ULNRC- 04558

**DOCKET NUMBER 50-483
CALLAWAY PLANT
UNION ELECTRIC COMPANY
RESPONSE TO REQUEST FOR ADDITIONAL INFORMATION
ON REVISION TO TECHNICAL SPECIFICATION 5.5.9
"STEAM GENERATOR (SG) TUBE SURVEILLANCE PROGRAM"**

**REQUEST FOR ADDITIONAL INFORMATION
REVIEW OF THE CALLAWAY PLANT APPLICATION
FOR REVISION TO TECHNICAL SPECIFICATION 3/4.4
TAC NUMBER: MB1214**

Figure R6-8. EDM Notch A10: Sleeved Region Outer Diameter, 0.003" depth

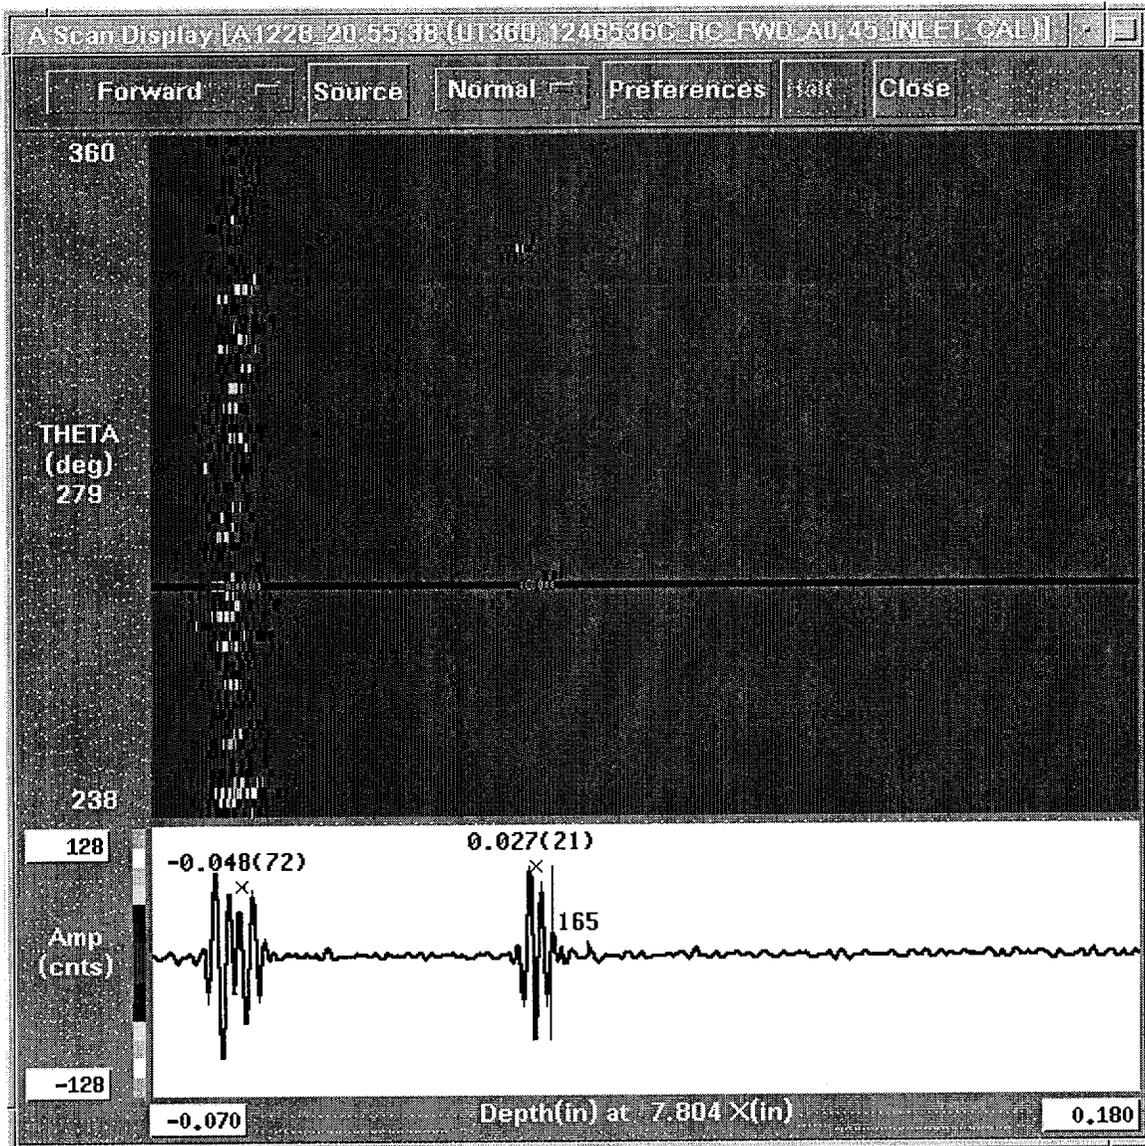
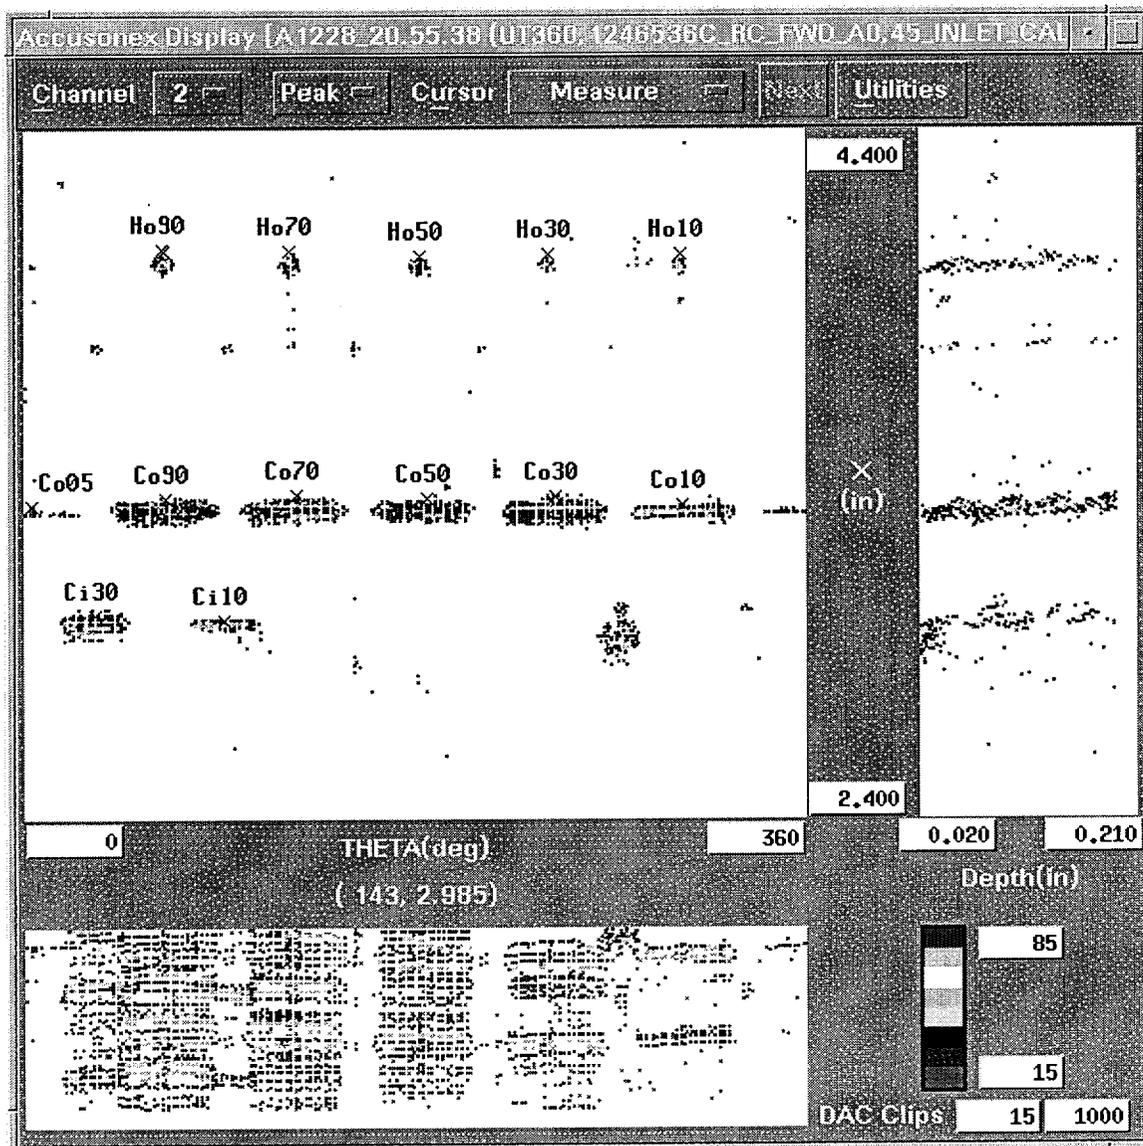
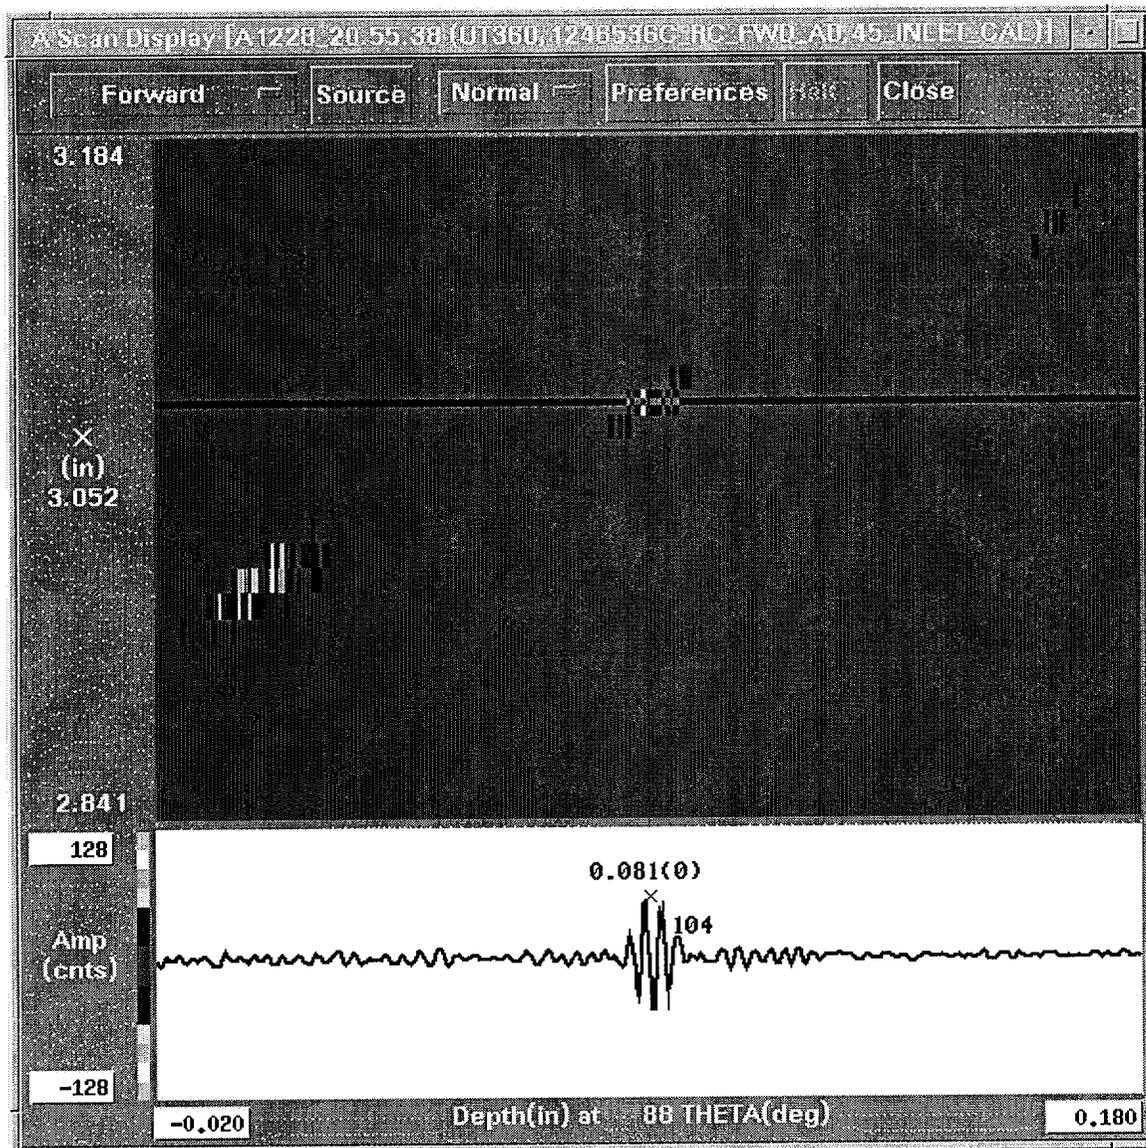
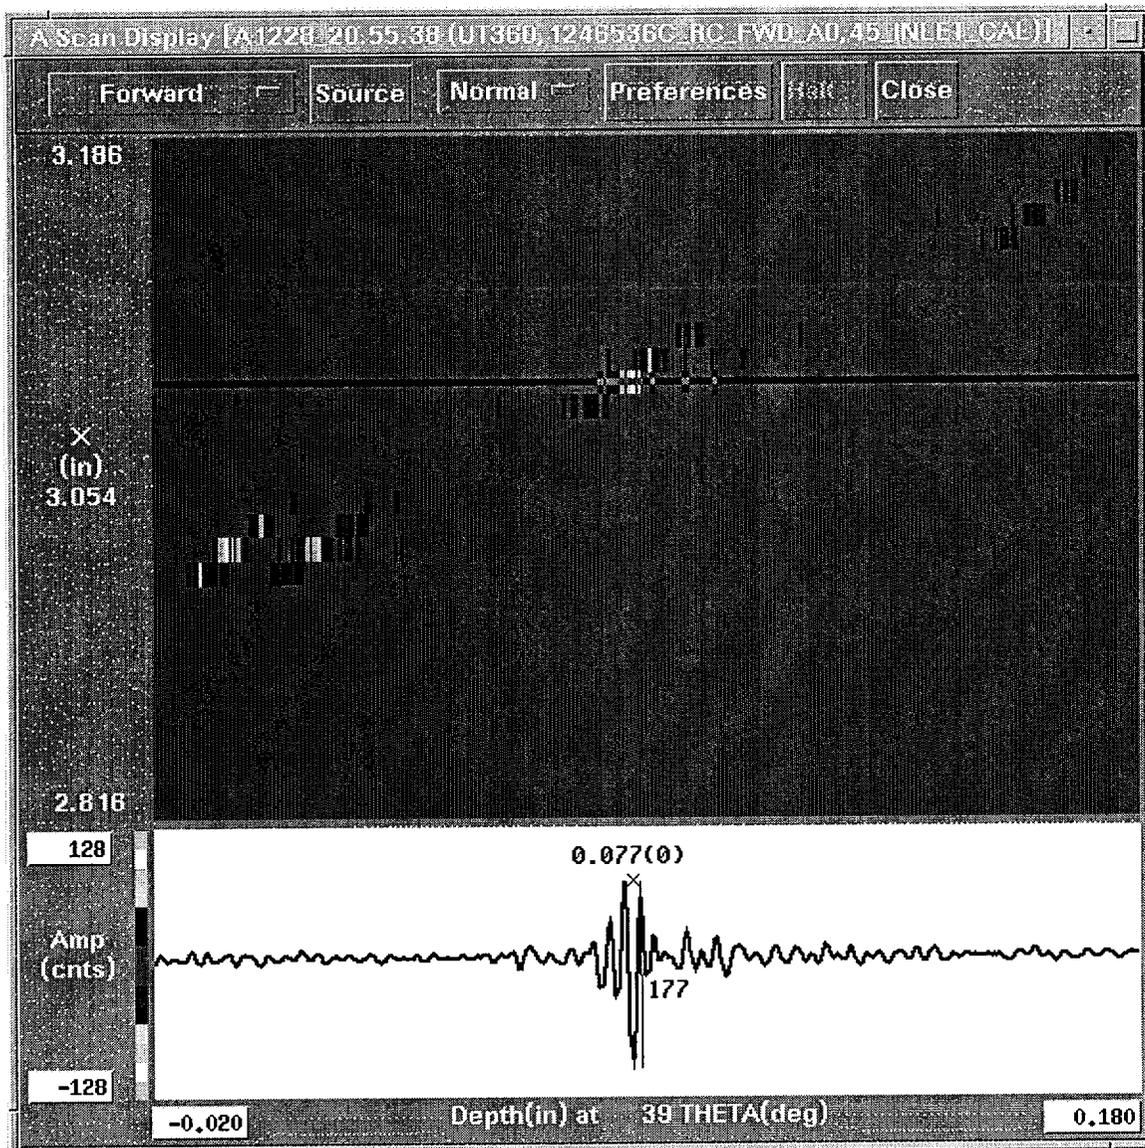
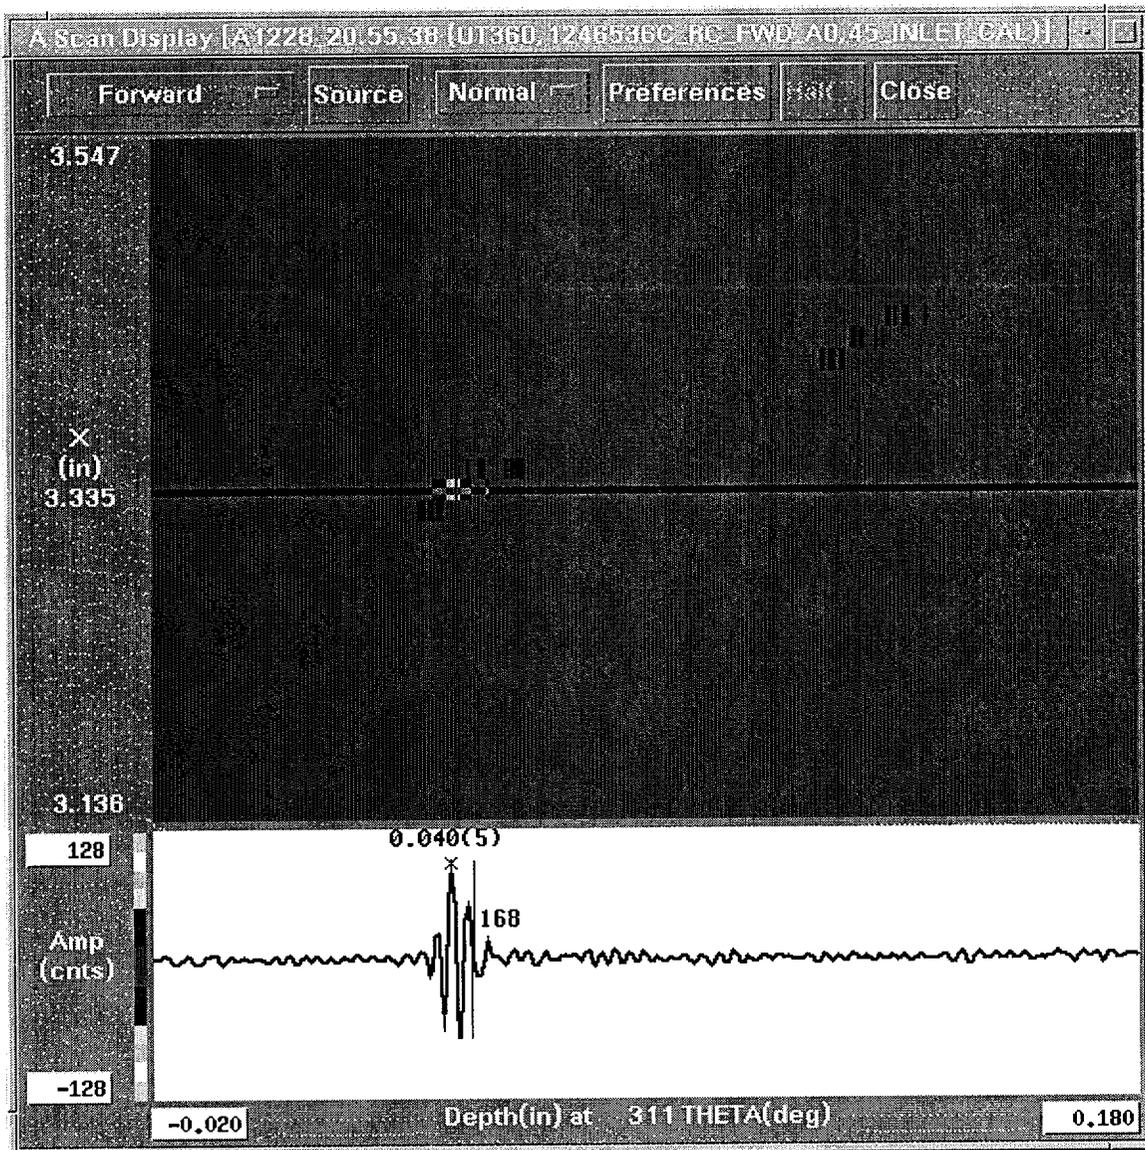
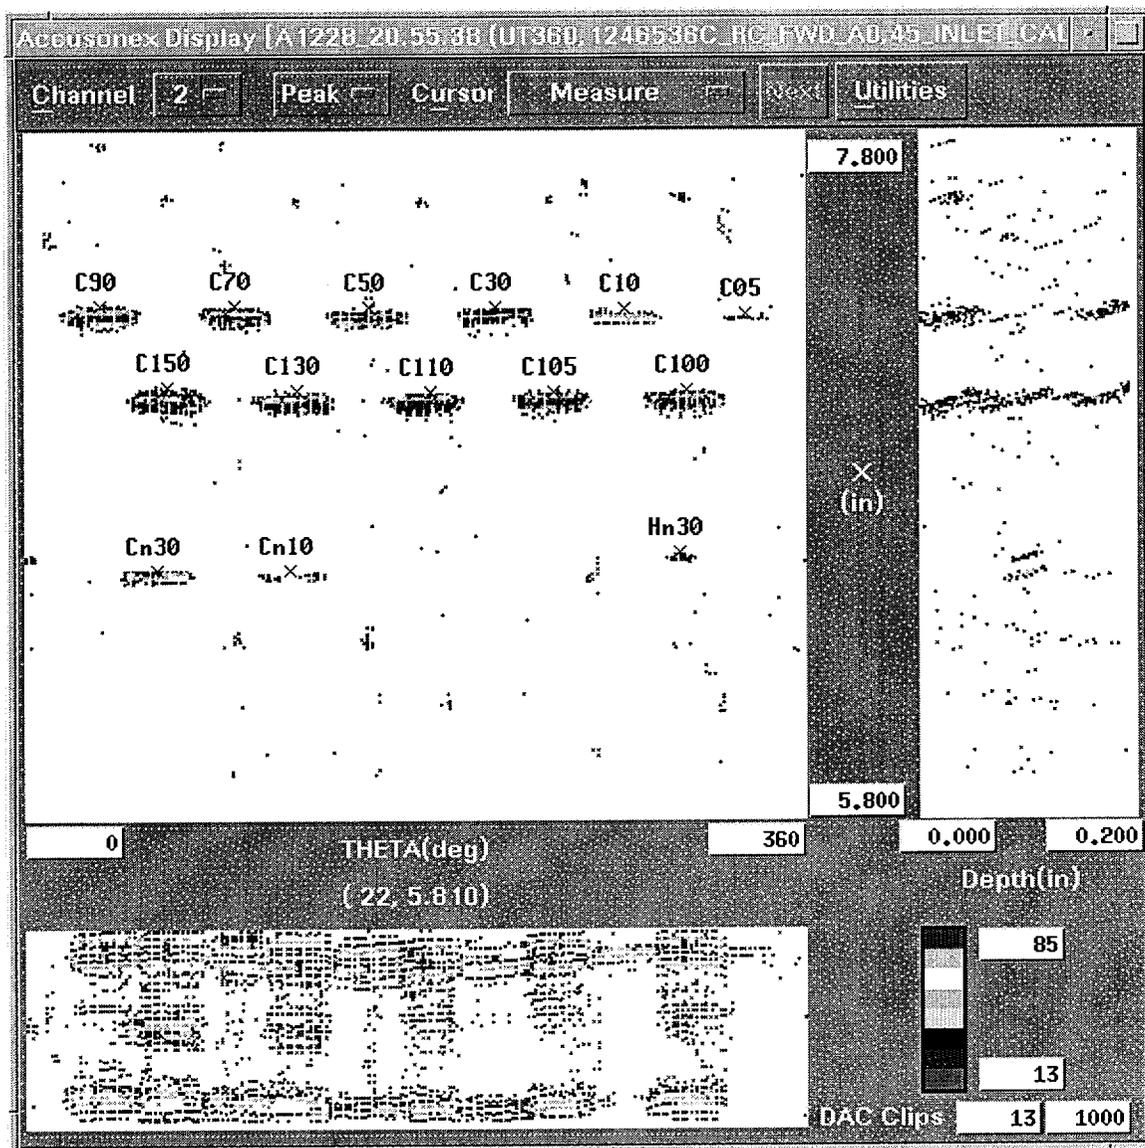
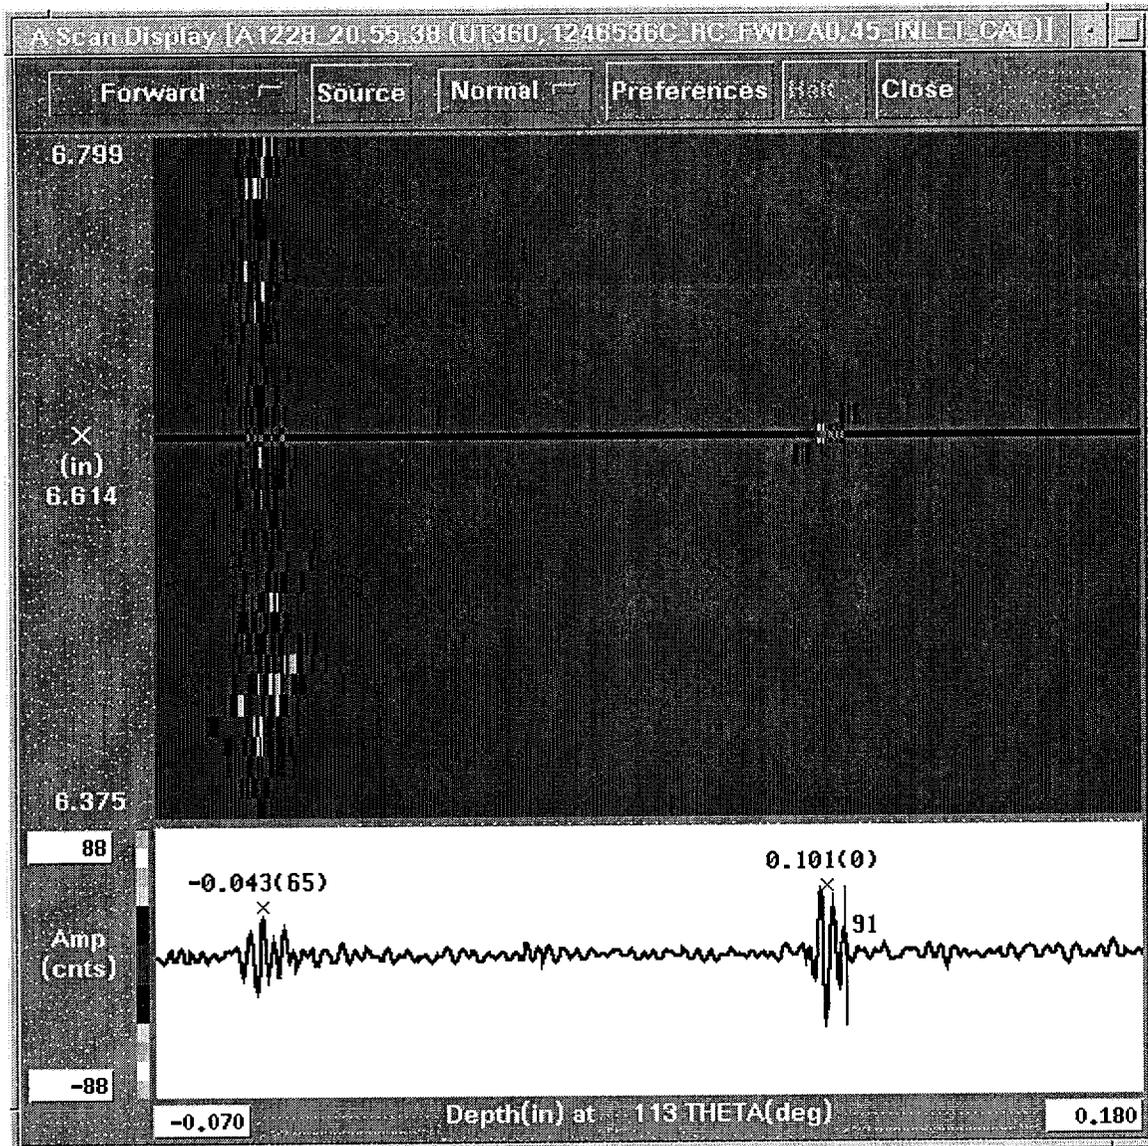
RAI # 6. During the meeting, FTI indicated that PWSCC detectability in the sleeve could be inferred from the ID notches in the UT calibration standards and the data sets containing pits. It is not clear to the staff how detecting EDM notches in the calibration standards or another degradation morphology such as pits would infer an ability to detect tight flaws such as PWSCC. Explain the basis for the statement that sleeve PWSCC ID defects will be detected, and the resulting sensitivity and POD, since the peer review (ETSS # 98404) only covers volumetric defects. Please provide additional discussion or, preferably, additional data to support the claims of the capability of the technique to detect PWSCC in the sleeve. (Question from the 6/7/01 meeting held with UE, FTI, and the NRC staff)

The assertion about the calibration standard and the inner diameter sleeve pit was to demonstrate sensitivity of the ultrasonic technique to inner diameter initiated flaws. The inner diameter pit provides a difficult cross-sectional target due to its cylindrical shape. This was felt to be a more challenging test of the detection capability of the shear wave transducers than the broad side of an EDM notch. The staff is correct in their opinion that neither of these flaws fully represent PWSCC, but these are the only morphologies available for evaluation since sleeve SCC cannot be fabricated.

To support the assertion that the system, (probe and technique) are sensitive to inner diameter flaws, three separate presentations will be offered. The first will show the sensitivity of the system to the inner diameter EDM notches in a calibration standard. The data was acquired in accordance with the

The flaws labeled "Ai" are parent tube inner diameter axial EDM notches. The flaws labeled "Ao" are parent tube outer diameter axial EDM notches. The flaws labeled with the first character "H" are EDM contoured bottom holes. Of interest is the detection of "Ai10", the 0.004 inch deep inner diameter notch.

This is the A-Scan plot showing the inner diameter corner reflection, (full skip) for the notch "Ai10". The notch is at the expected depth for the full skip, (two times the wall thickness) 0.086 inch. The peak to peak amplitude of this reflection is 65 counts out of a possible 256 counts or 25% full screen height.

This is the A-Scan plot showing the inner diameter corner reflection, (full skip) for the notch "Ai30". The peak to peak amplitude of this reflection is 108 counts or 42% full screen height.

This is the axial EDM notch that is used to establish the sensitivity and time-of-flight to depth calibration. The sensitivity must be set between 50% and 80% of the digitizer full scale. For an eight bit digitizer, the full scale is 256 counts (cnts). The amplitude of this reflection is 178 counts or (178/256), 70%.
